Addenda No. 3

PREPARED BY: Michael Gumbel

SUBJECT: OR 99/238 Paving (Grants Pass) Section
Rogue River/Jacksonville Highway
Jackson County
Paving & Drainage Project
(Bids to be opened and read January 22, 2009)

SHEET NO. 2

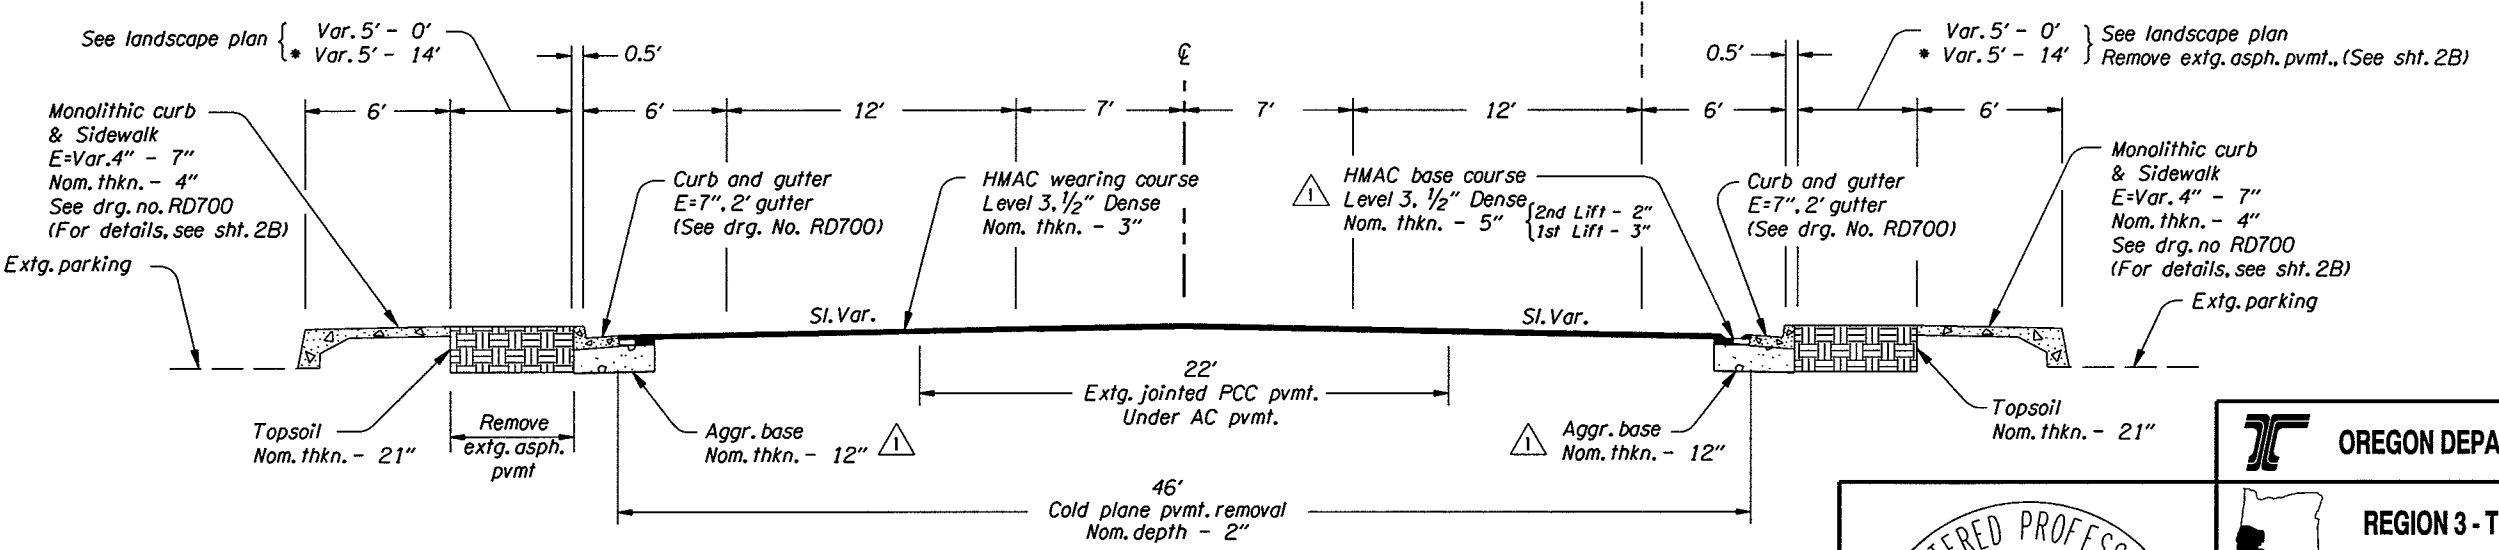
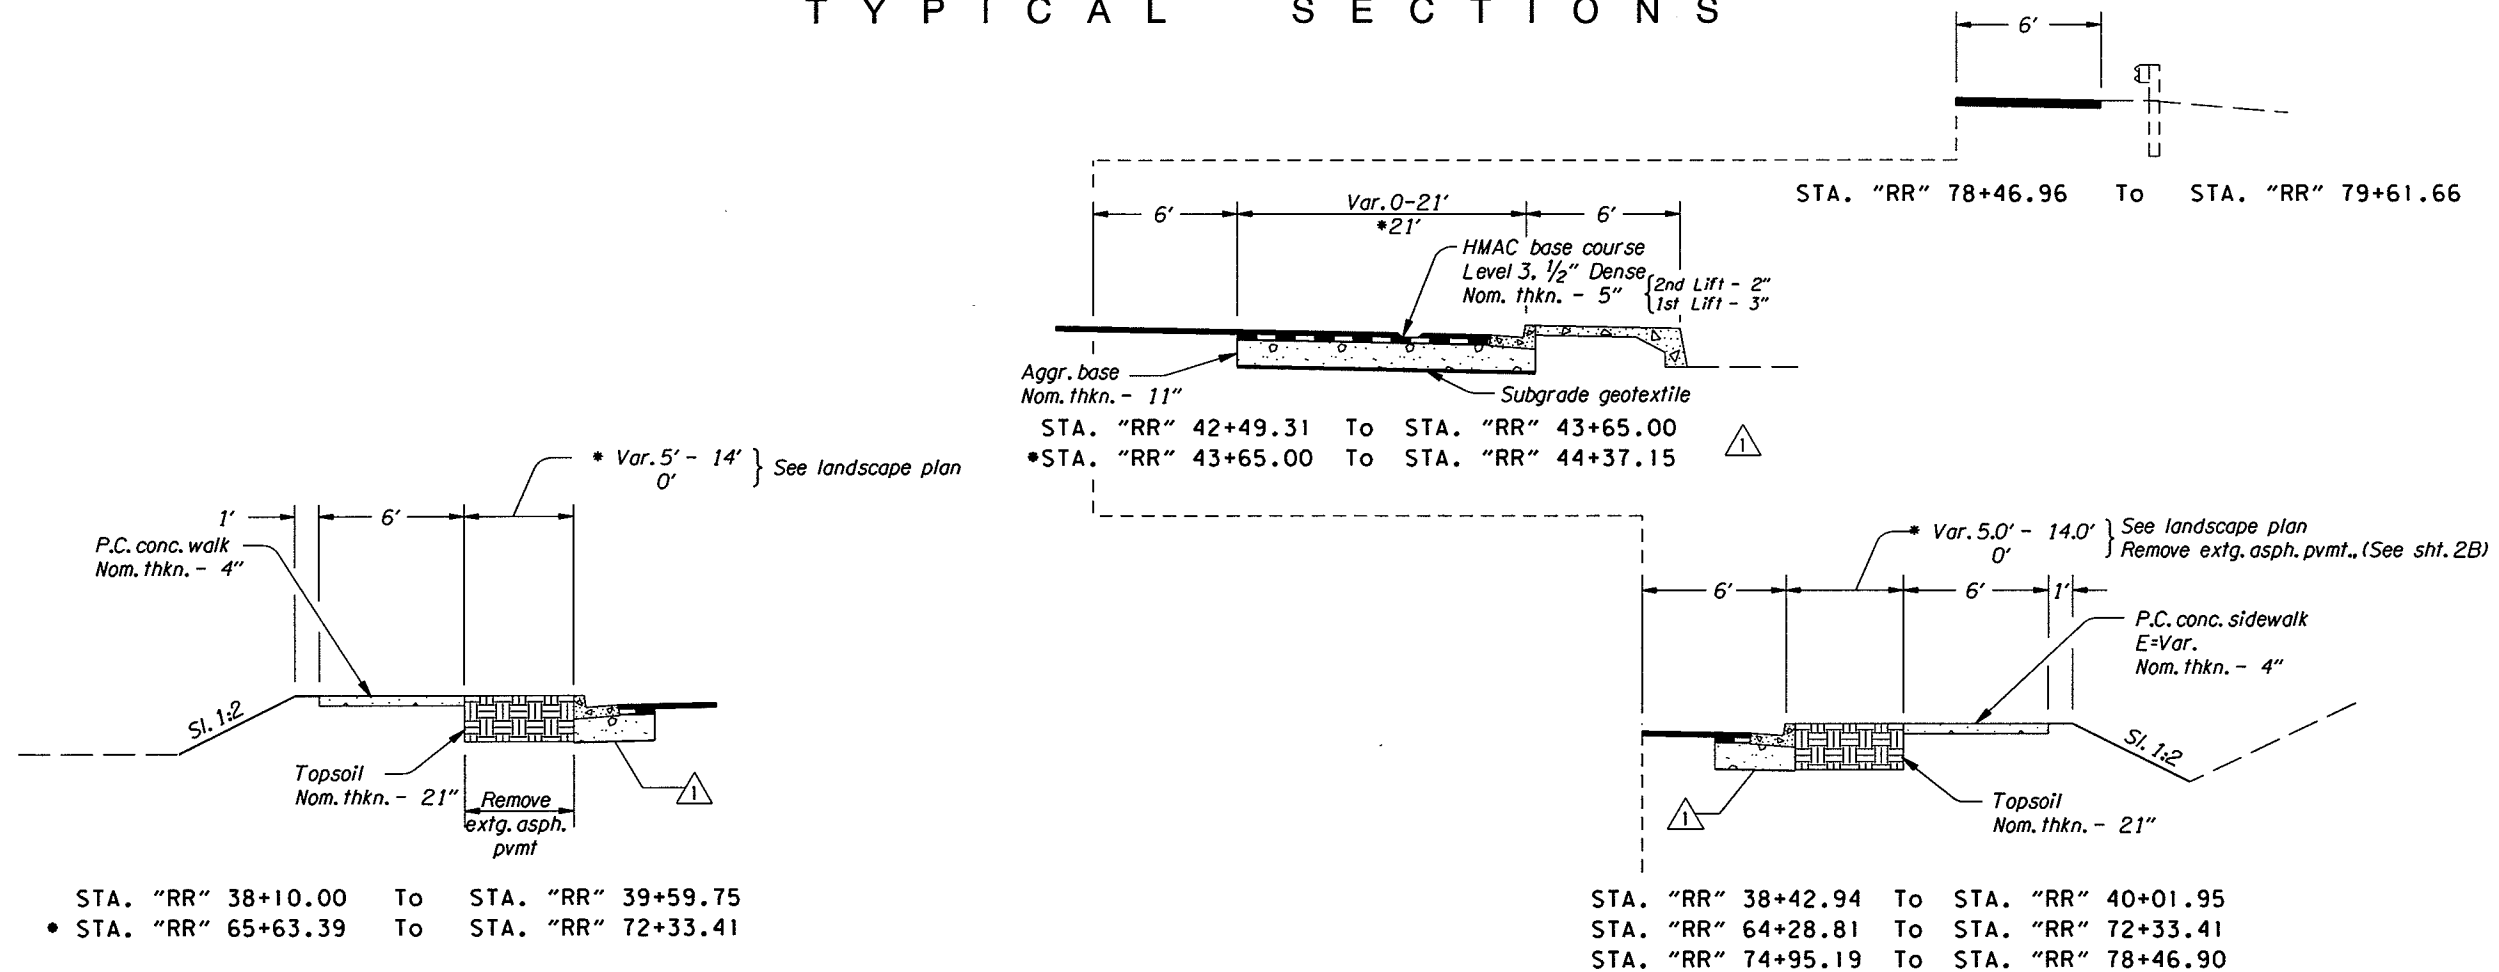
| Rev. No. | Description | Date | Engineer |
|----------|-----------------------------------------------------------------------------|----------|--------------|
| 1 | Revise base course from: 4" to 5" Chg. Nom. comp. thkn. from: 12" to 11" | 12-30-08 | Chris Zelmer |

SHEET NO. **2A-3**

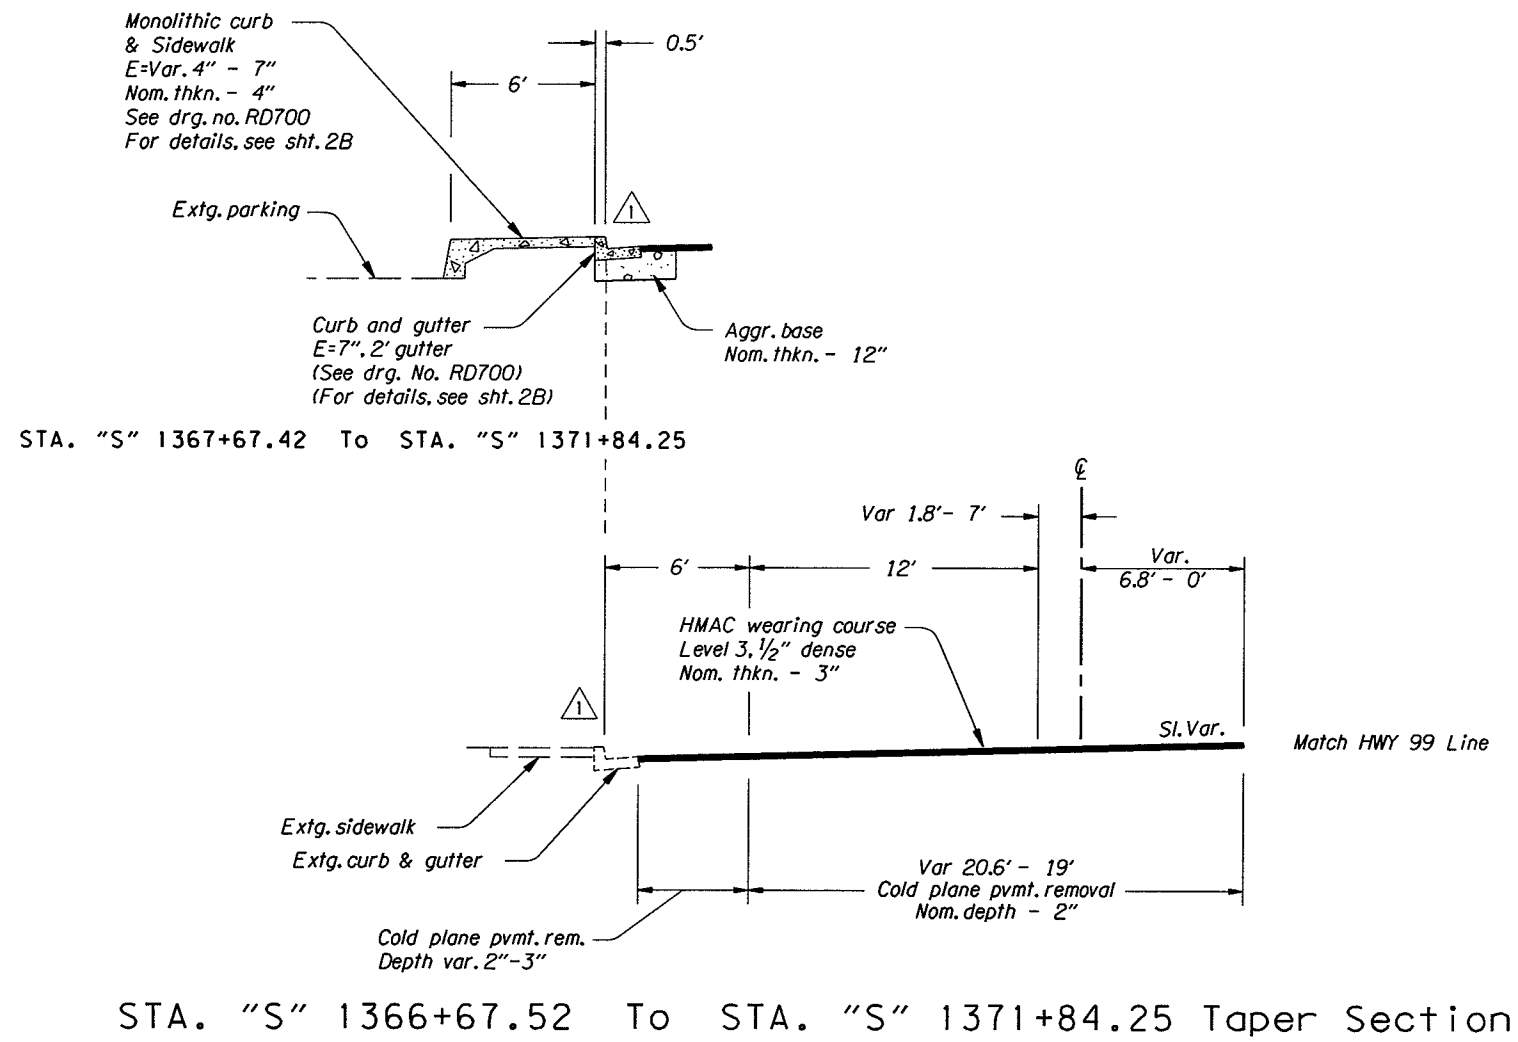
| Rev. No. | Description | Date | Engineer |
|----------|------------------------------------------------------|--------|--------------|
| 1 | Added aggregate base 12" under curb / gutter & stack | 1-9-09 | Chris Zelmer |

| TYPICAL SECTIONS | SHEET NO. 2A-6 |

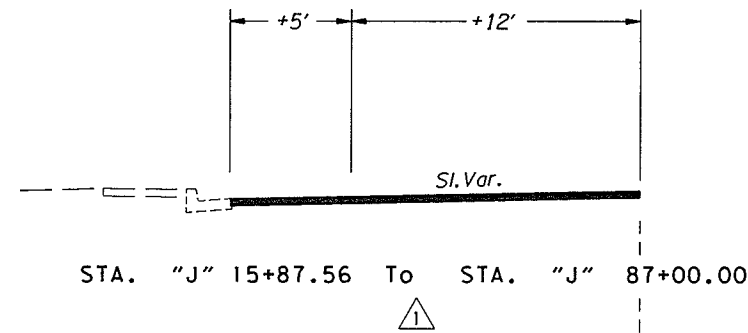
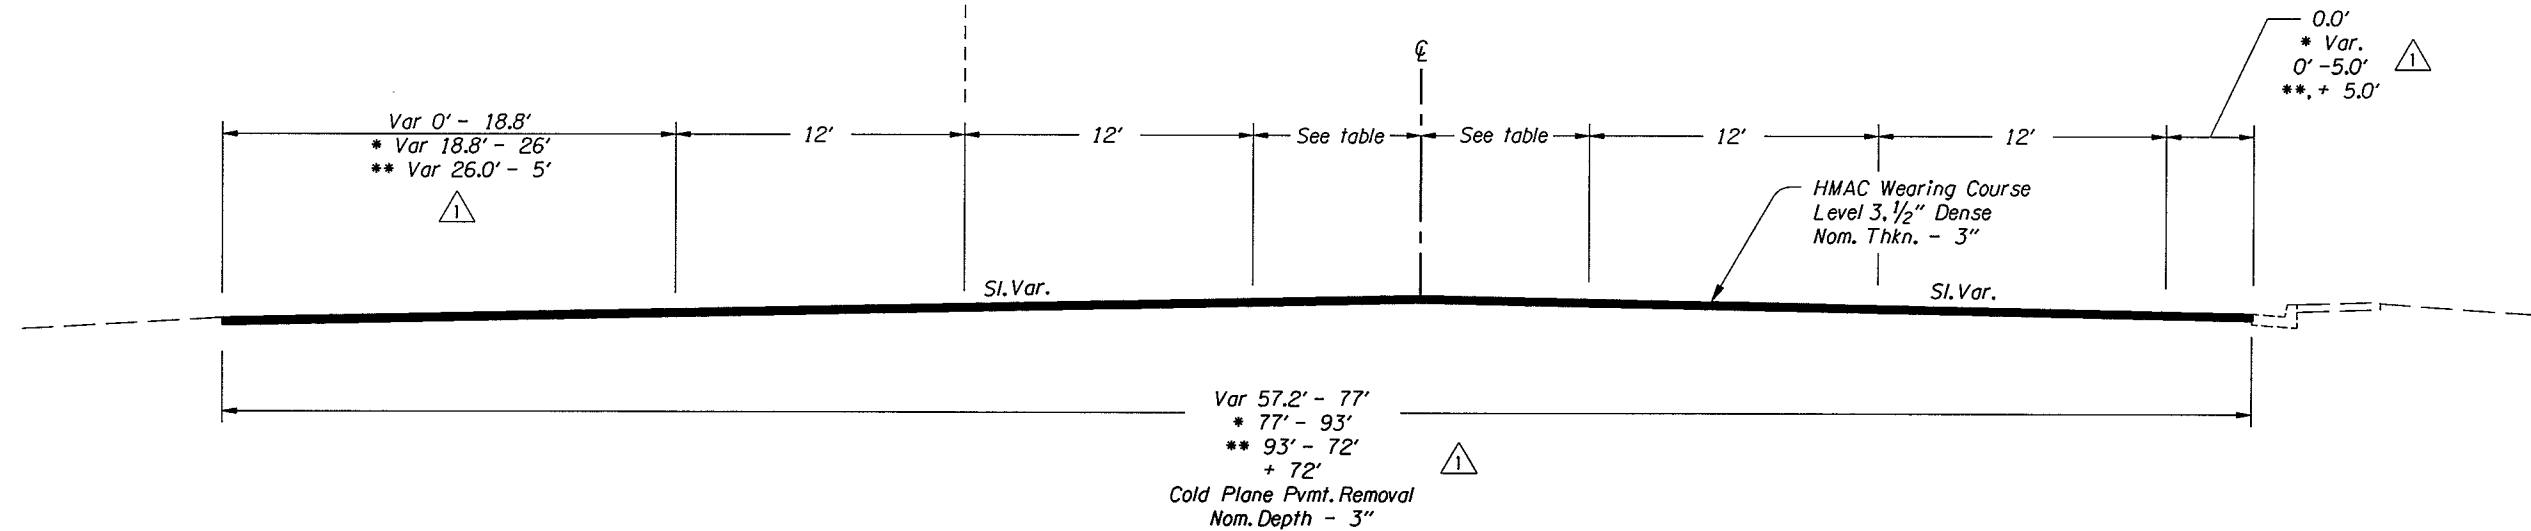
| Rev. No. | Description | Date | Engineer |
|----------|-----------------------------------------------|---------|--------------|
| 1 | Moved dim's from edge of asph to edge of curb | 1-12-09 | Chris Zelmer |

TYPICAL SECTIONS SHEET NO. 2A-8

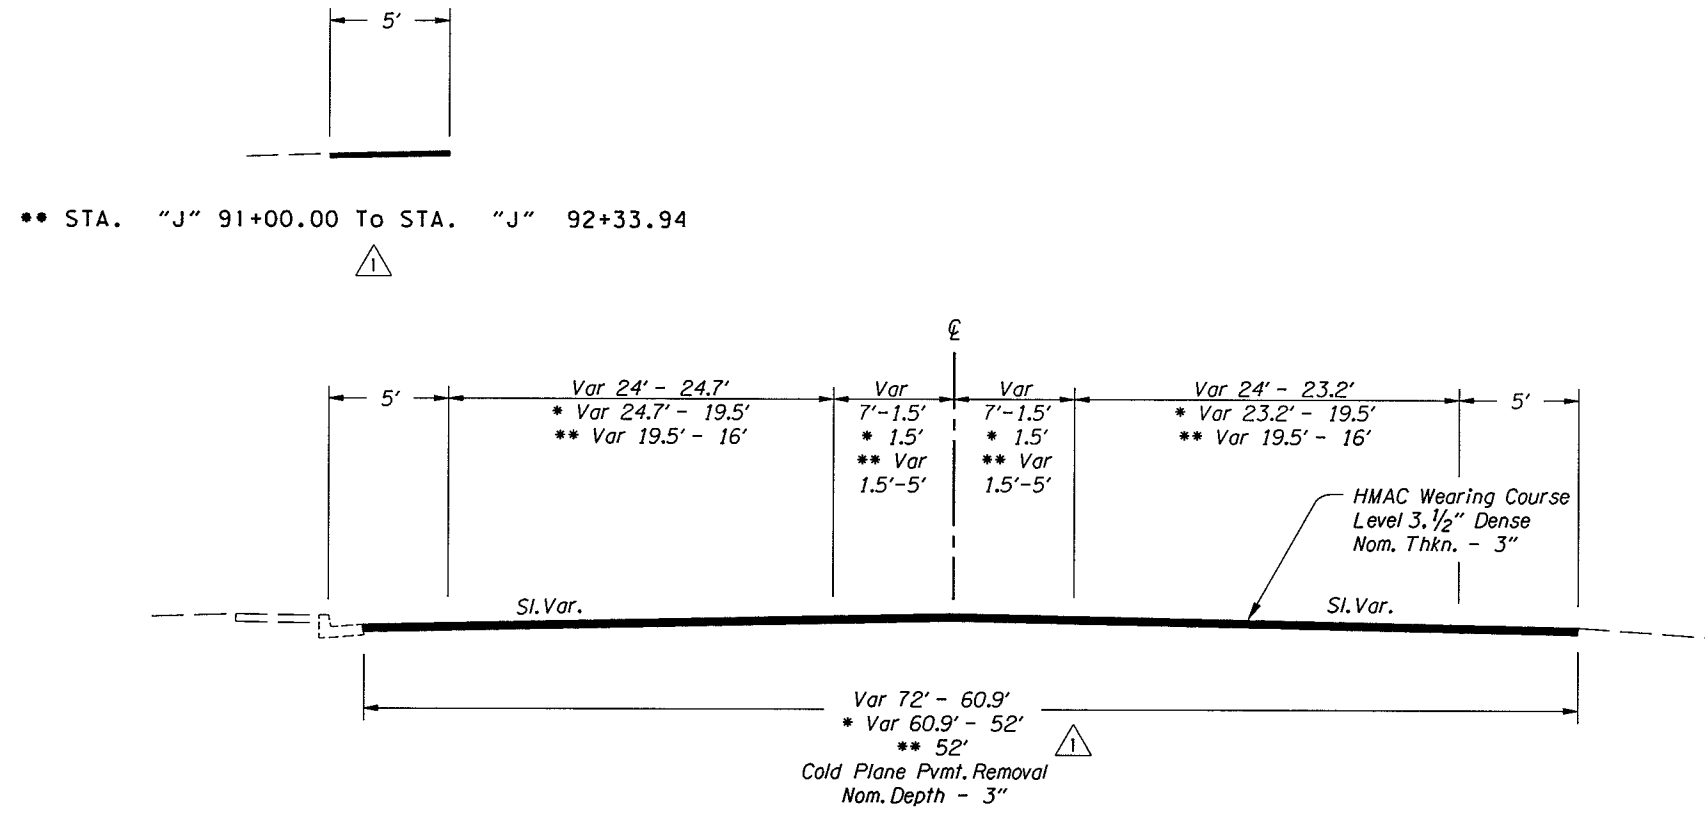
| Rev. No. | Description | Date | Engineer |
|----------|------------------------------|---------|--------------|
| 1 | Moved stack, chgd dimensions | 1-12-09 | Chris Zelmer |

SHEET NO. 2A-9

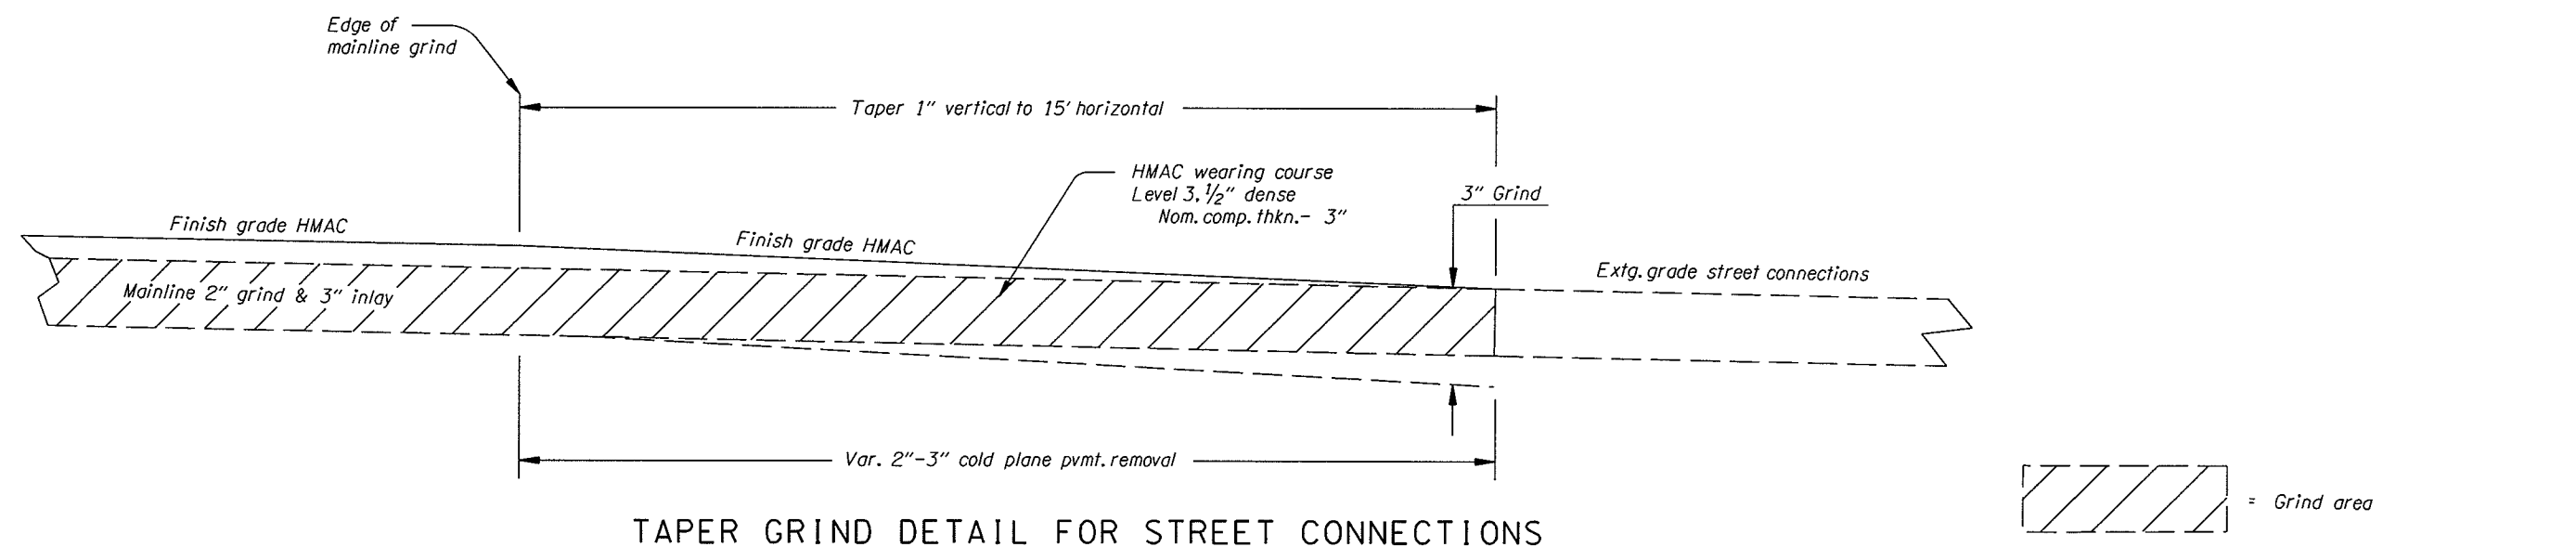
| Rev. No. | Description | Date | Engineer |
|----------|------------------------------|---------|--------------|
| 1 | Moved stack, chgd dimensions | 1-12-09 | Chris Zelmer |
